Dixie-Narco®

Service Bulletin

213

SUBJECT: Free Vend (Direct Power) Jumper

VIEW LOOKING DOWN ON TOP
OF RELAY BOX

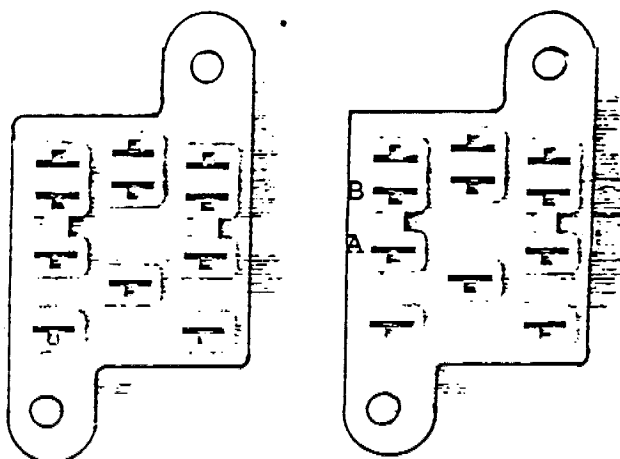
3. Put one end of jumper in vend relay socket at terminal "A" shown below and other end in terminal "B".

"A" is the common of vend relay Sw2 and "B" is normally open of vend relay Sw2. This will send 24 volt power to valve without the use of relays.
